The following drawing index sheet and reference drawings have been added to Volume 3.

DESIGN OF NEW STAIR FOR BETHESDA STATION - CONTRACT NO. 13-FQ1 0060-MCAP-19

RED LINE REHAB.-FRIENDSHIP HEIGHTS TO GROSVENOR - PART 6
PHASE 1B SECTIONS
SCALE AS SHOWN
DRAWING NO. A09-A-301
SHEET NO. M1272-195

SCALE AS SHOWN
DRAWING NO. **A11-A-102**
SHEET NO. **M1272-146**

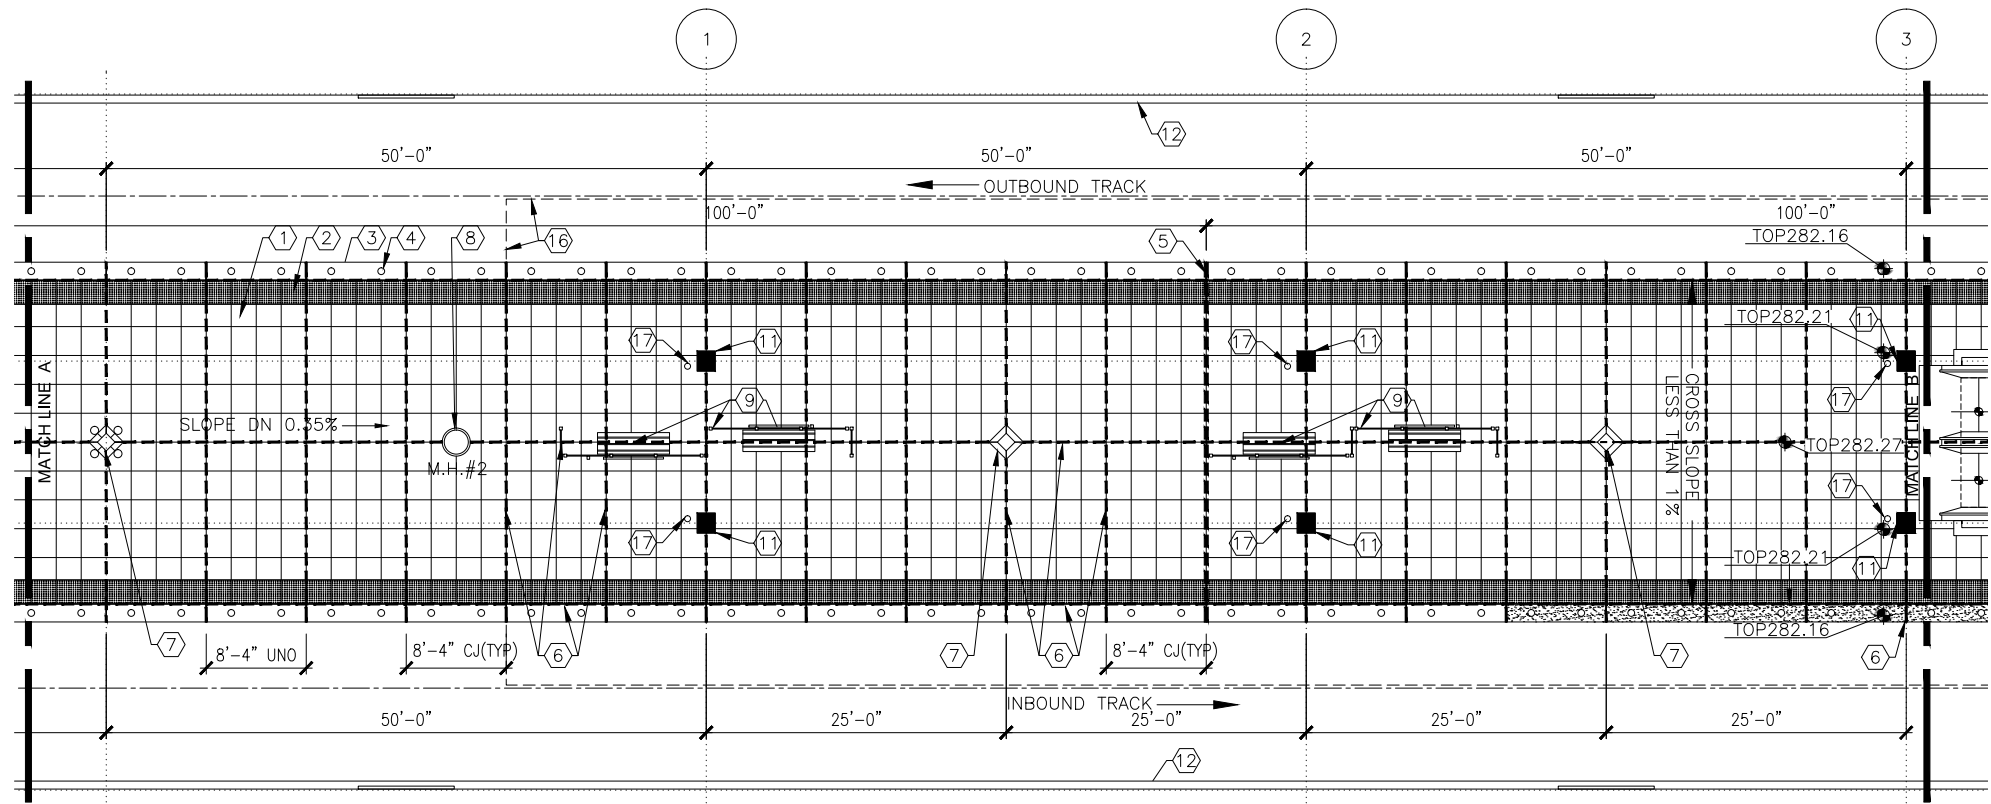
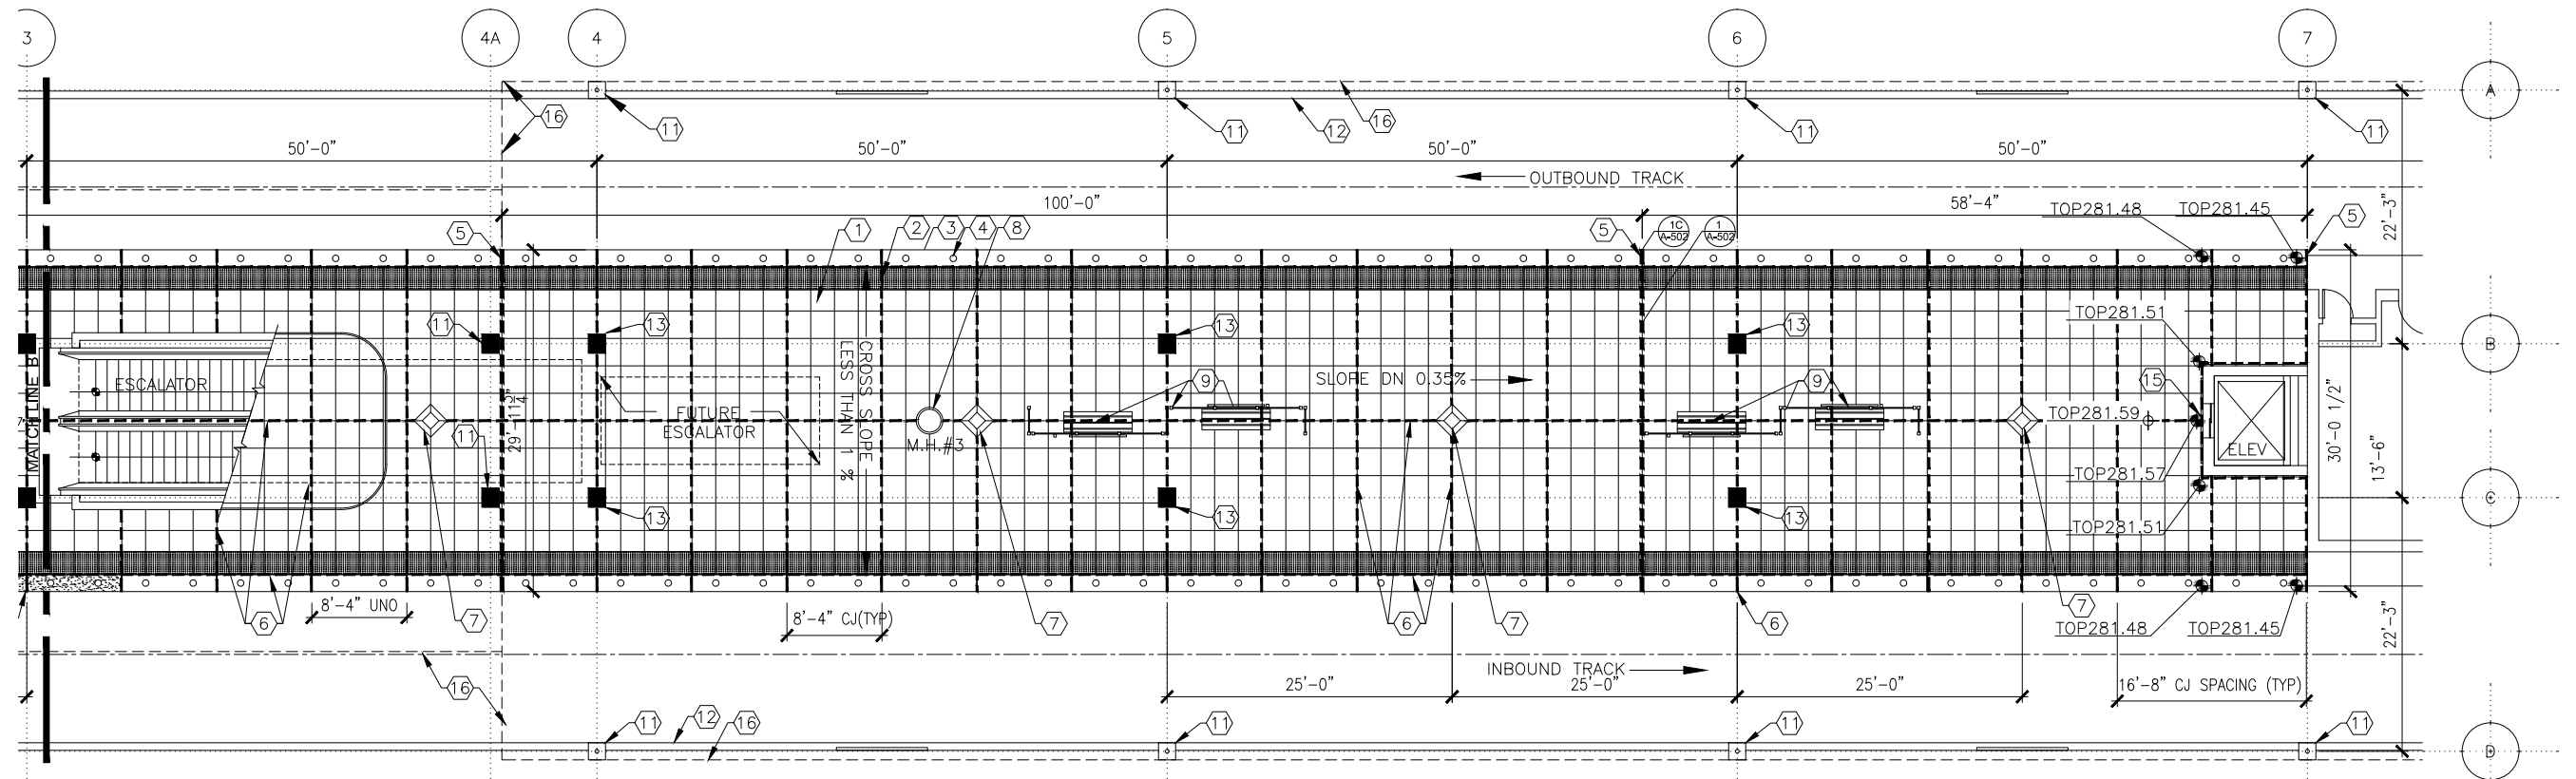
- ① NEW PRECAST PAVERS (25"x29" NOM) (TYP).
- ② NEW TRUNCATED DOME PRECAST PAVERS 25" x 24" (NOM) (TYP).
- ③ NEW GRANITE EDGES. **AM2**
- ④ NEW GLASS LENSES. **AM2**

- ⑧ INSTALL NEW LIDS WITH EMBOSSED METRO LOGO IN EXISTING FRAME. REFER TO **AM2** WMATA STANDARD DETAIL.
- ⑨ EXISTING BENCHES & WINDSCREEN TO BE REINSTALLED AT THE EXISTING LOCATIONS. SEE DETAILS 3-4/A-501.
